**Fire hazard testing - Part 2-10: Glowing/hot-wire based test
methods - Glow-wire apparatus and common test procedure
(IEC 60695-2-10:2021/COR1:2024)**

The text of the corrigendum IEC 60695-2-10:2021/COR1:2024 was approved by CENELEC as EN IEC 60695-2-10:2021/AC:2024-01 without any modification.

IEC 60695-2-10
Edition 3.0 2021-10

C O R R I G E N D U M 1

Figure C.1 – Times and durations (in accordance with Clause 3)

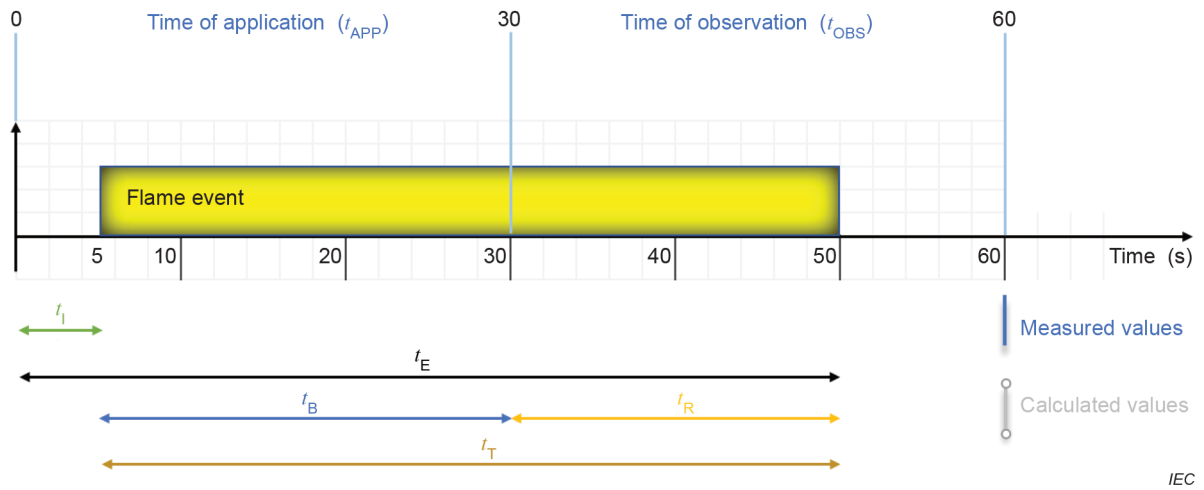
Figure C.1 – Times and durations (Example: ignition occurs at 5 s and extinguishing occurs at 50 s)

Replace the existing title of Figure C.1 with the following new title:

Replace existing Figure C.1 with the following new figure:
